STATE OF DELAWARE
DEPARTMENT OF TRANSPORTATION
800 BAY ROAD
P.O. BOX 778
DOVER, DELAWARE 19903

February 17, 2009

DeIDOT Contract Number: 95-090-01; Federal Aid Project Number: IM-N056(27)
I-95 Delaware Turnpike Improvements Project
I-95/SR 1 Interchange/I-95 Turnpike Mainline
Turnpike Mainline from SR 1 to SR 141; I-95/SR 1 Interchange; I-95 Northbound
Widening Extension
New Castle County, Delaware
Environmental Reevaluation [*Change in interchange design*]

The current reevaluation details modifications in the design of the I-95/SR 1 interchange portion of the project. The design changes are being incorporated into the project to provide additional traffic operational and safety improvements within the interchange. An environmental evaluation of the currently proposed design has been completed, and the changes would increase the impacts to wetlands by an additional 0.26 acres. Mitigation for this additional impact will be accommodated within the Cathcart wetland mitigation site (identified as Site 7 in the

PLAN LEGEND

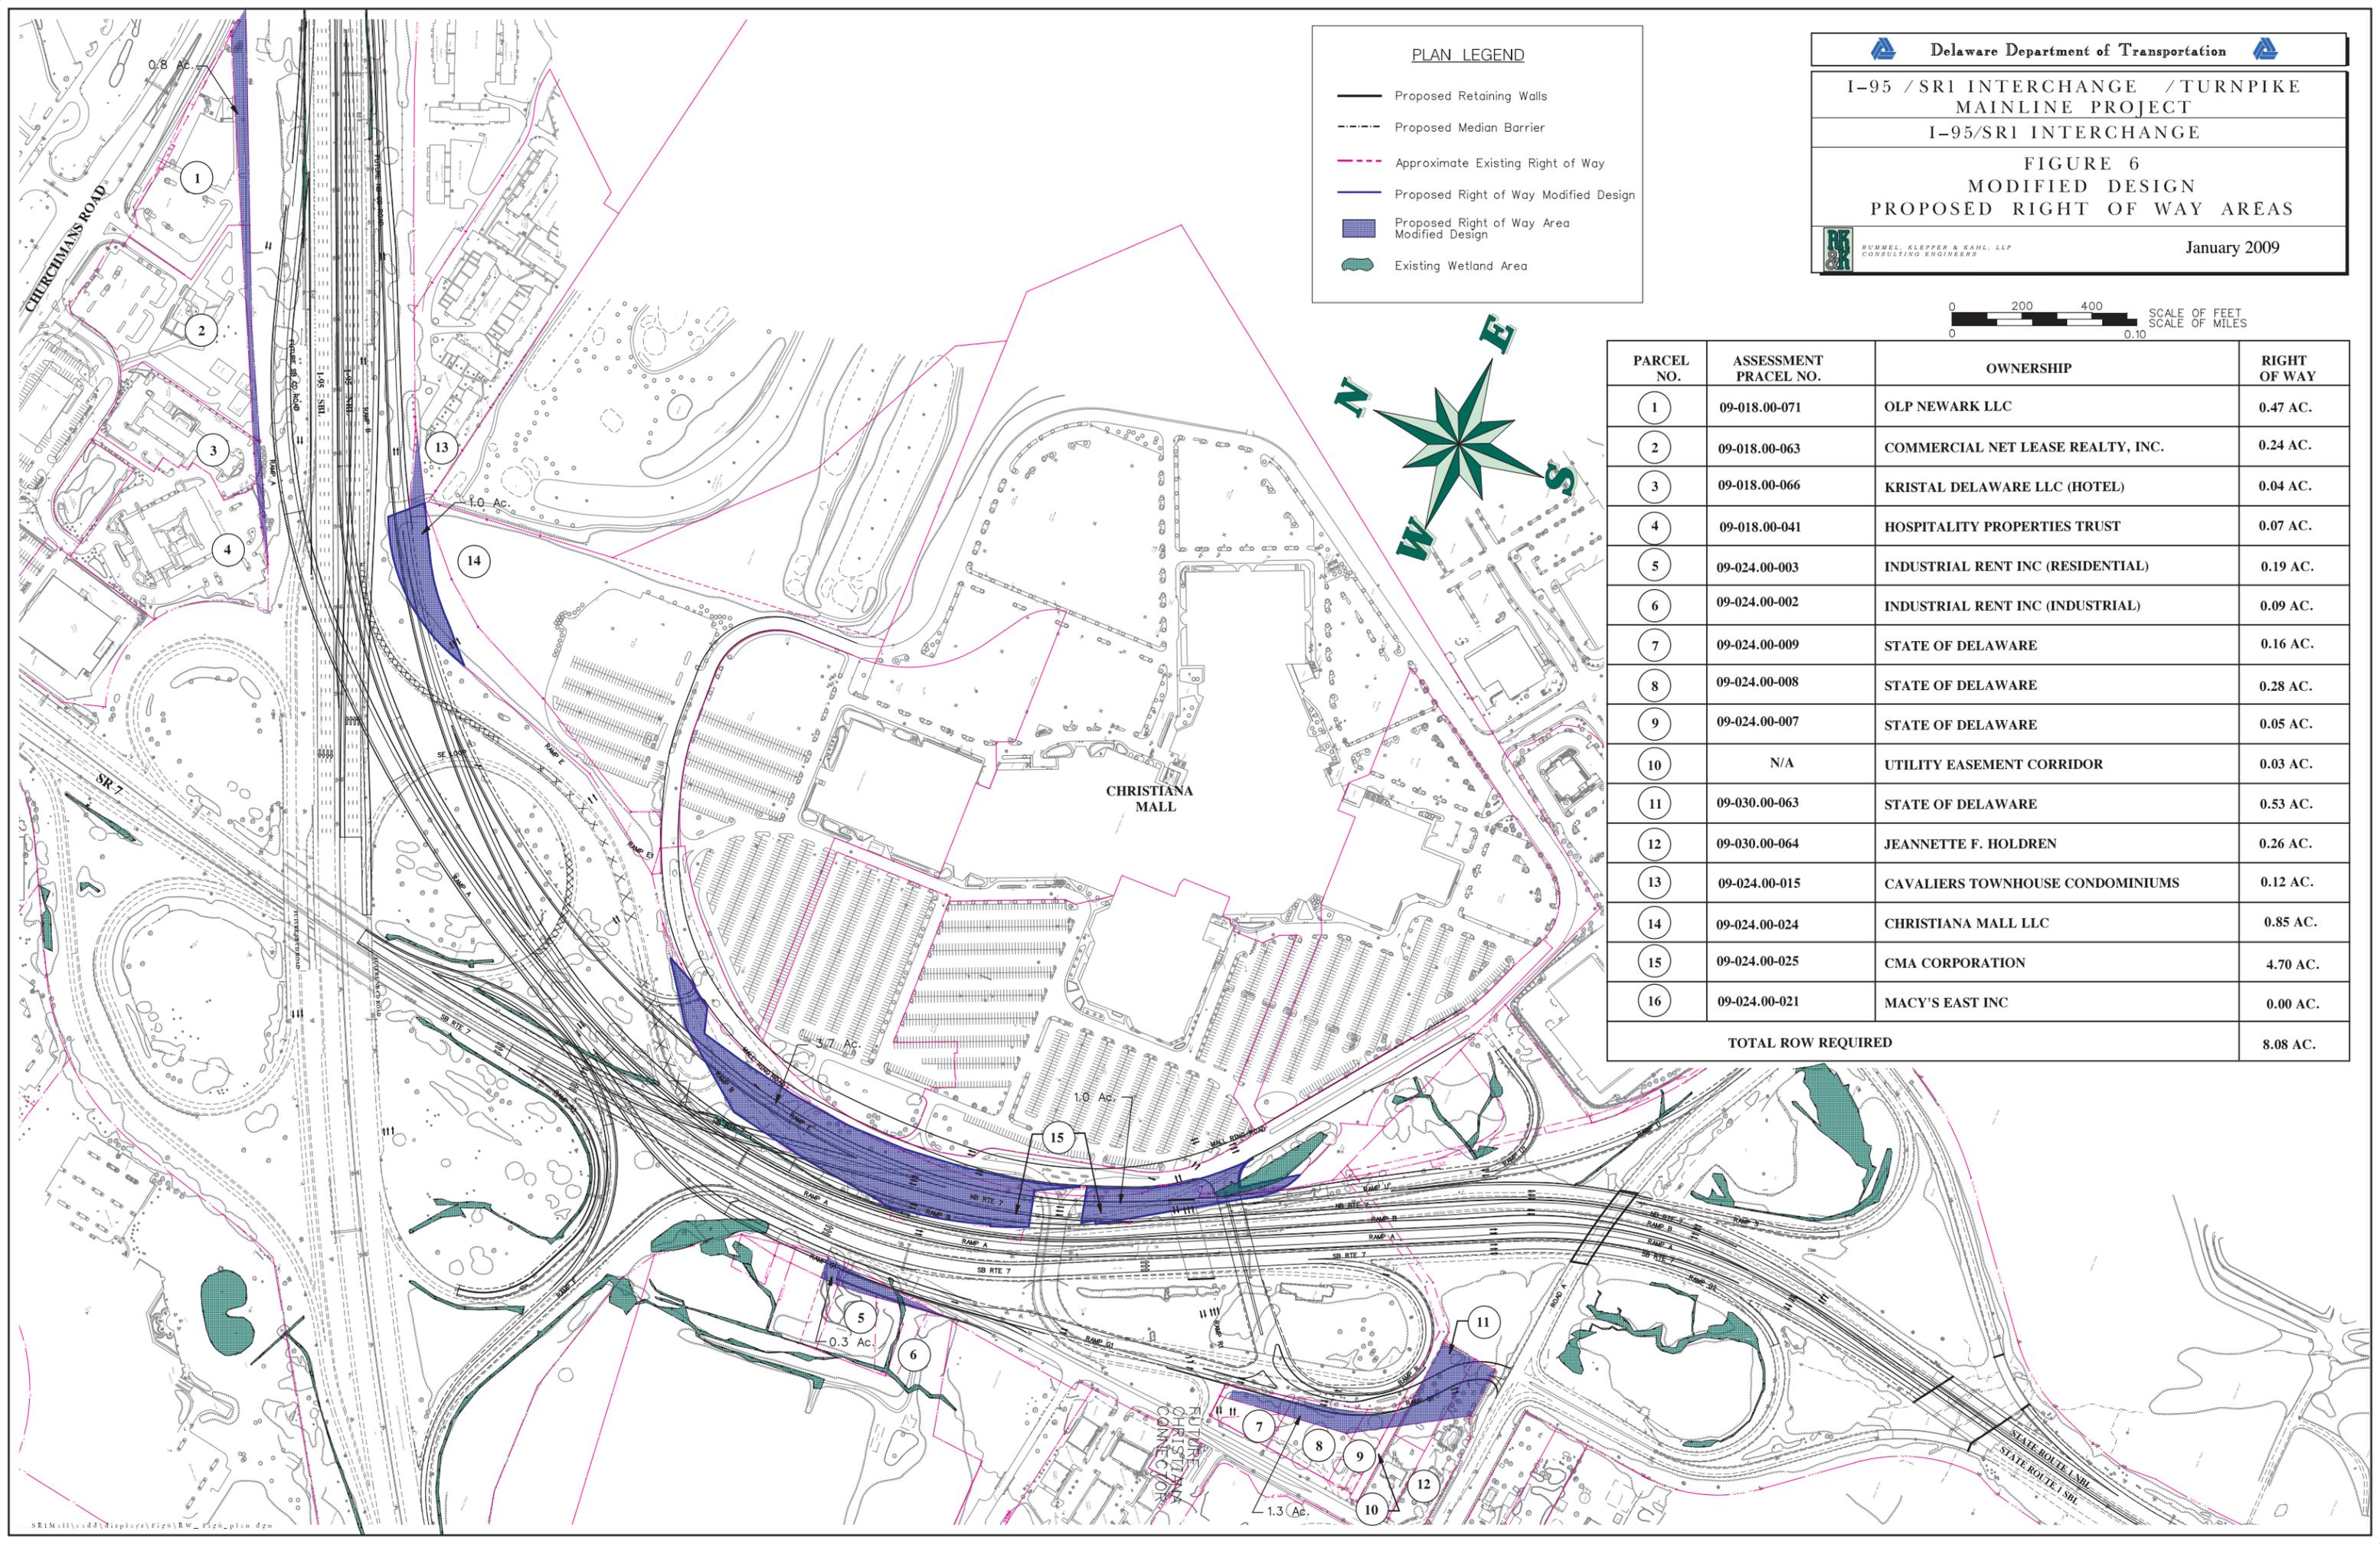
Potential property impacts resulting from the current design of the I-95/SR 1 interchange are shown on **Figure 6**. The modified design of the interchange will result in a total acquisition of 8.08 acres as compared to 9.41 acres proposed to be acquired in the FONSI design.

I-95 / SRI INTERCHANGE IMPROVEMENTS
 I-95 / SRI INTERCHANGE
COMPREHENSIVE WETLAND IMPACTS

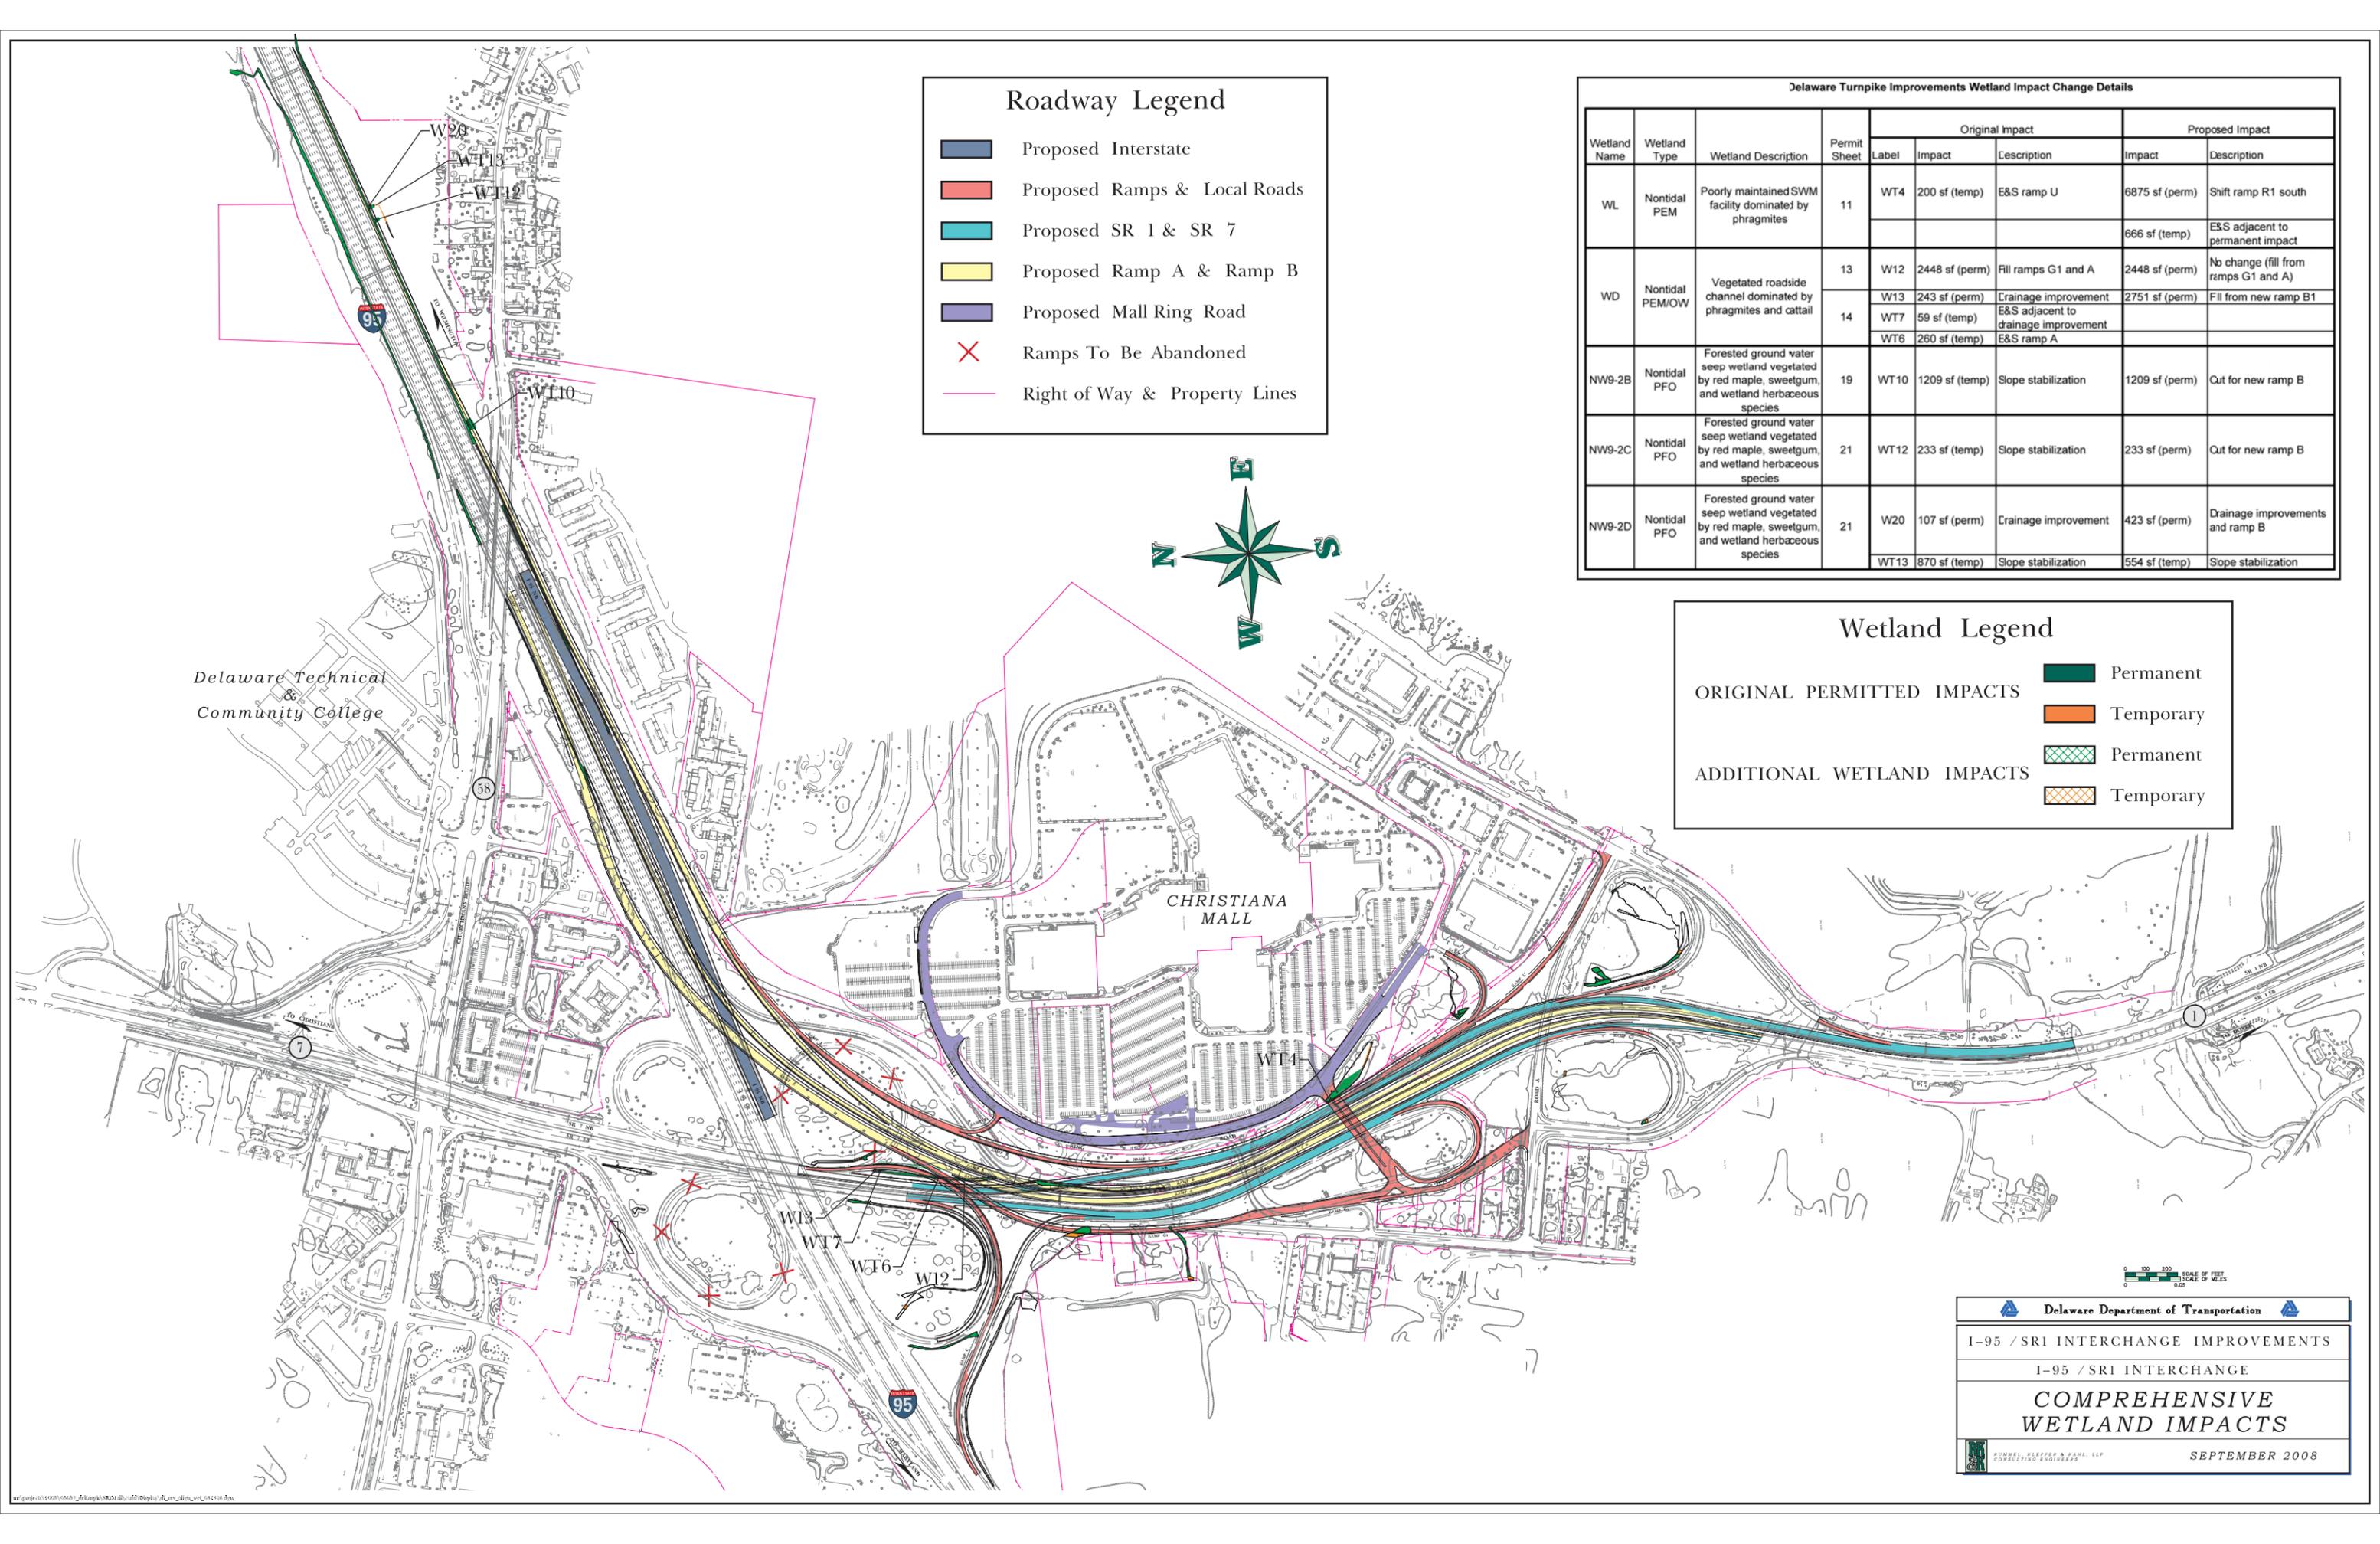
- The existing NB I-95 to NB SR 7 movement is accomplished via a loop ramp following a weave on I-95. To eliminate this weave a semi-direct flyover ramp is proposed.
- Preliminary design included a flyover ramp to provide access to the Christiana Mall. To allow for adequate clearance over SR 1 this ramp has been shifted to the south a few hundred feet.

- The shift of the Mall access flyover will permanently impact an additional 6,875 square feet (0.16 acres) of emergent wetlands.
- In total, the design modifications will cause an additional 11,141 square feet (0.25 acres) of permanent impacts to wetlands and will reduce the total temporary impact to wetlands by 1,611 square feet (0.04 acres). [*After the meeting the additional impacts were calculated considering the three forested wetlands as total takes, the additional permanent impact is 11,863 square feet (0.27 acres) and the temporary impacts are reduced by 2,333 square feet (0.05 acres).*]

- *After the meeting, the mitigation ratios were applied to impacts that included the forested wetlands as total takes resulting in required mitigation of 55,676 square feet (1.28 acres).*
- DelDOT proposed that no additional mitigation was required since the required mitigation for the project is less than the mitigation provided for the project
- ACOE agreed that no additional mitigation would likely be required for the project. Further ACOE stated that no permit actions would be taken on this issue until a permit modification was requested by DelDOT. DelDOT should request this modification when plans and details of the SR1 phase of the project are available.
